1804 E SPRUCE ST

SECOND EARLY DESIGN GUIDANCE MEETING

EARLY DESIGN GUIDANCE 212 18TH AVE - # 3023583
EARLY DESIGN GUIDANCE 208 18TH AVE - # 3023584
EARLY DESIGN GUIDANCE 1804 E SPRUCE ST - # 3023032

EDG 1 MEETING - COMMENTS & RESPONSE

FOURTH SCHEME: PREFERRED

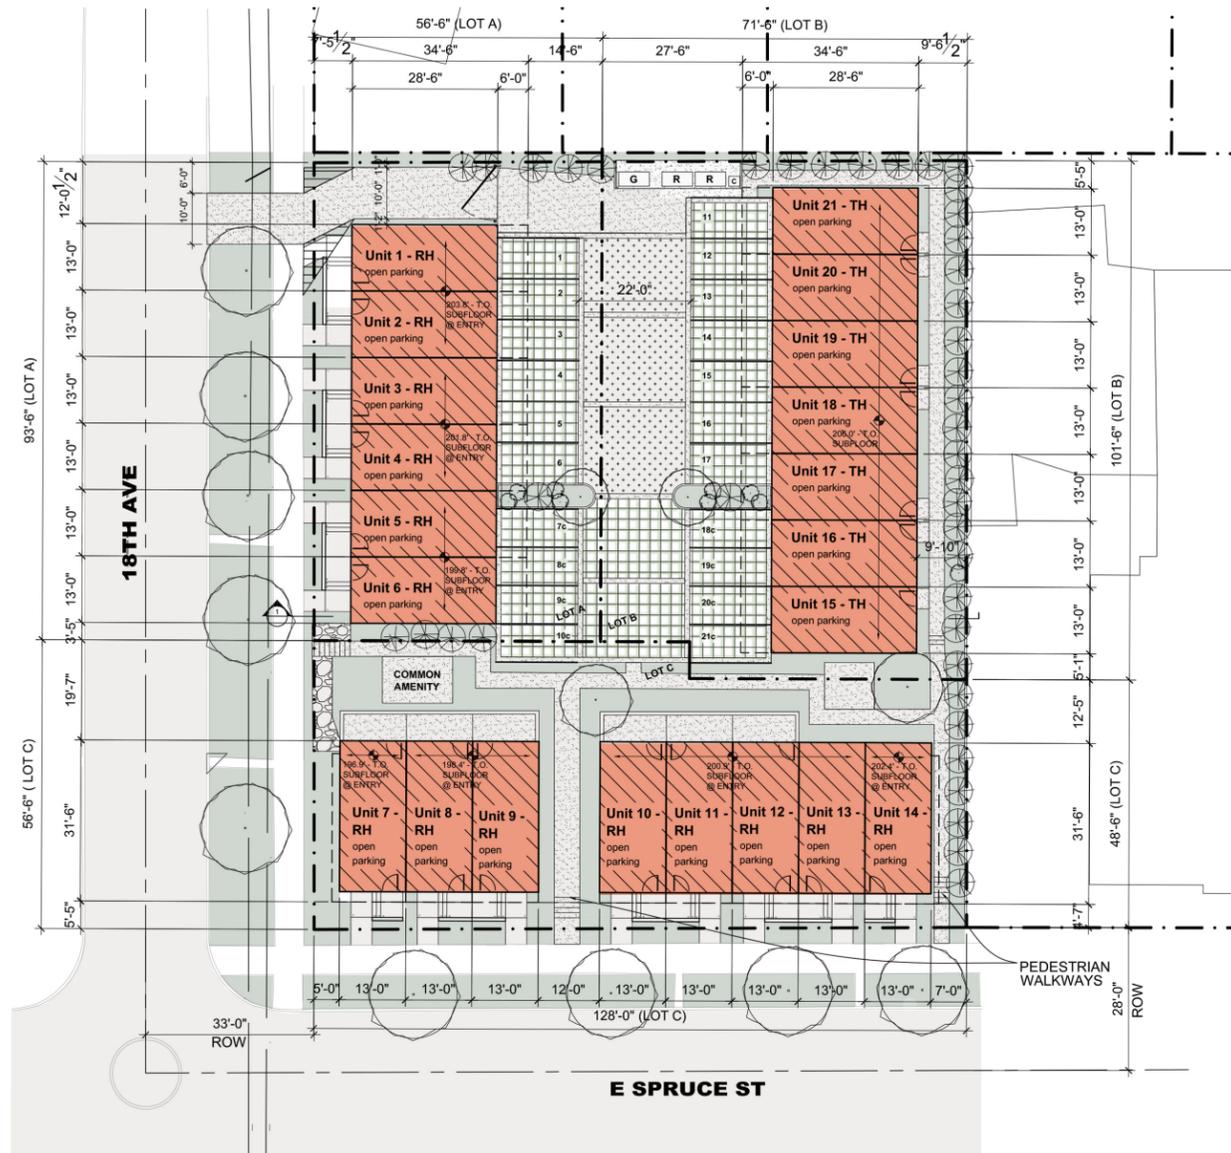
| 1. The mass of the structures is overbearing and should be eroded to reduce the visual impact of the upper floors. | 1. The building has been pushed down into the site to reduce the height, bulk and scale. The unit entries are now within 30" above the sidewalk grade. |
| 2. The bulk should be further reduced by using a more transparent parapet. | 2. The parapets are broken up to have areas with transparent railings. The corner unit on 18th and E Spruce has a full transparent railing to reduce the visual scale of the building. |
| 3. The penthouse stairs should be more internal to each structure to reduce the height of the buildings. | 3. The penthouses on units 1-6 and 15-21 are located at the center of the building so as not to be visible on the exterior facade. Units 7-14 have open stairs to the roof deck which reduces the visual apparent height. |

| 1. Lack of connection between townhomes and the amenity area. Units along eastern property line should be connected to amenity areas and have less isolated pedestrian circulation. | 1. The central amenity space has expanded by moving the driveway to the north part of the site. This opens up the center of the site for amenity space and pedestrian paths. The units along the east are accessed from the central amenity area or the path along the east property line. |
| 2. Stoops should clearly mark residential entries while provided large enough landing areas for a gathering space. | 2. The stoops have increased in size from 3' to 5' wide. They are paired so two units share one stoop. A brick clad wall has been integrated to create a threshold from the sidewalk as well as create a place to pause to interact with neighbors or to find your keys. |
| 3. Residences should be grouped together and separated from the parking to create more cohesive residential spaces. | 3. The parking is internal to the site keeping it visually separated from the street. The units front the street to create a strong urban edge while forming a common amenity space at the center of the site. The setbacks are gracious along all edges to incorporate the stoops - this enhances the residential experience along with creating a positive transition from public to private. |

4. The design should clearly commit to either large stoops or larger amenity space, not a half measure of each.

4. Although recommended to commit to either a larger stoop or larger amenity space, we've opted to enhance both the stoops and the amenity space. We feel both are assets to the project and site and both should be committed to. Therefore, the stoops have been enlarged and are a shared feature along the street edge. The amenity space was made larger by shifting the driveway to the north part of the site. This opened up the space between the buildings and allowed us to activate the site with common shared spaces and private back patios. The south portion of the parking court has pavers to blend into the common area, creating a larger gathering space for the residents.

The new fourth scheme includes moves to reduce the massing of the street-facing units as well as create better amenity space and entry stoops. The driveway has been shifted to the north part of the site, utilizing the existing curb cut. The driveway will be buffered for screening along the North property line. The parking area is separated into two zones using landscaped islands and paving changes to reduce the apparent depth and create a stonger link to the shared green space. The parking court acts as a flexible space giving the residents options for how they want to use the space. The court terminates at a large green space in the middle of the site. This green space acts as common amenity, transition through the site, and an open space to make the site feel less dense. The units along E Spruce St have been redesigned to put the living-dining-kitchen on the first floor and have an open exterior stair for roof deck access. The entries along 18th Ave and E Spruce St have stoops that are 5'-0" wide and feature brick detailing to proved a relationship to the existing building and to create a welcoming area that transitions from public to private. Landscape buffers are integrated along the entire east property line to create privacy from the neighboring Boys and Girls Club.

LANDSCAPE PLAN

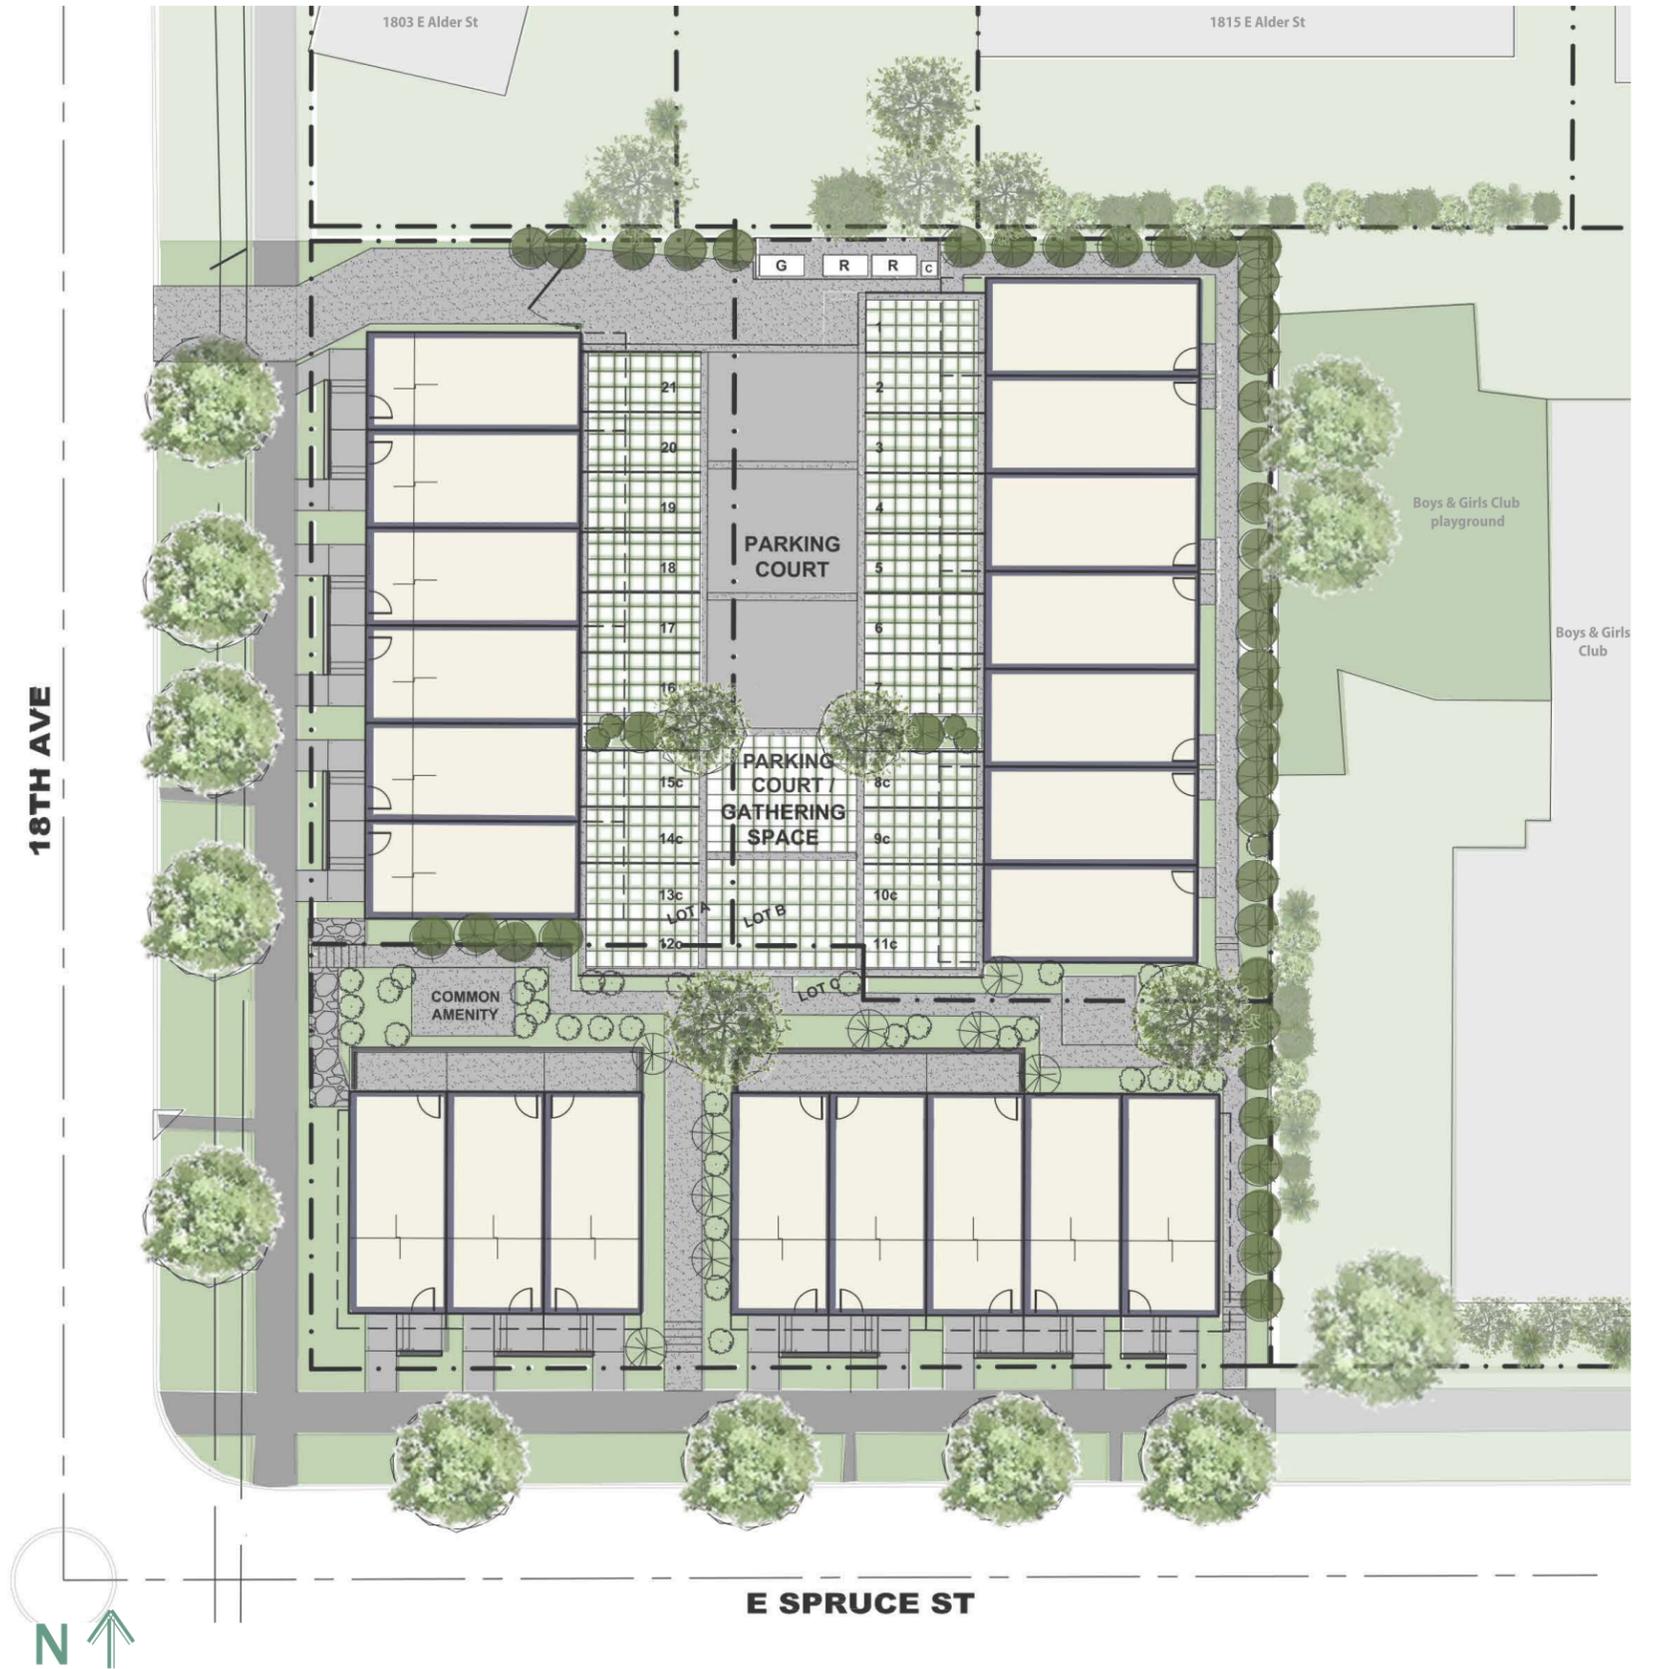
2. Landscape buffers should be included to the east for the Boys and Girls Club and the north bordering single-family residences

2. Landscape buffers are integrated along all edges of the site especially along the east for the Boys and Girls Club and the north for the single-family residences.

The landscape for the project plays a significant role in activating the outdoor spaces. The driveway into the project needs to be functional yet appealing to drivers entering the site. The pedestrian paths also need to feel inviting. The common driveway is flanked with parking spaces that are intended to be permeable. The paving provides an attractive look to the inner parking court. The theme is then carried to the common amenity spaces. This helps with the infiltration on site and provides a flexible space for the community members to gather.
